Rover
British Leyland UK Limited
Sohull, Warwickshire, England

January, 1973

INDEX Vol. 1 Nos. 10 and 11

Fig. 1 Impulse tool kit 530101A

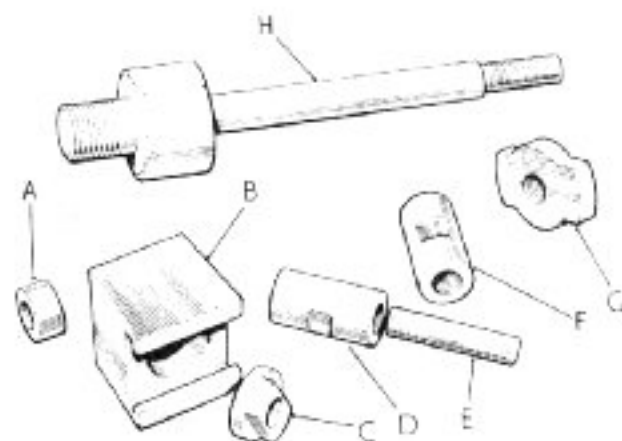
MODIFICATION: Introduction of an adaptor kit to suit impulse tool 18G284, to aid commonisation. The kit also provides all the adaptors previously included with impulse tool 530101.

REMARKS: When stocks of the earlier impulse tool and adaptor kit 530101 are exhausted only the above listed tool kit 530101A will be stocked. The kit is for use with the current impulse tool 18G284 which, if not held, must be ordered separately.

Fig. 2 Torque spanner adaptor RO 1013 for mainshaft nut spanner

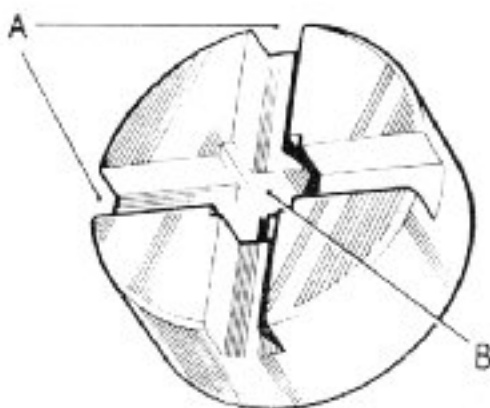
MODIFICATION: Introduction of a torque spanner adaptor for use with the existing box spanner, Part No. 600300, for the gearbox mainshaft nut.

REMARKS: The current gearbox build specification requires the special nut Part No. 217477 at the transfer gear end of the gearbox mainshaft to be tightened to 12,5 kgf.m (90 lbf.ft.) prior to turning up the lockwasher. The above listed adaptor is now available for this purpose and is designed to fit on the end of the existing mainshaft nut spanner Part No. 600300. It is recommended that this torque loading be applied on earlier, as well as later, gearboxes during the applicable overhaul procedure.
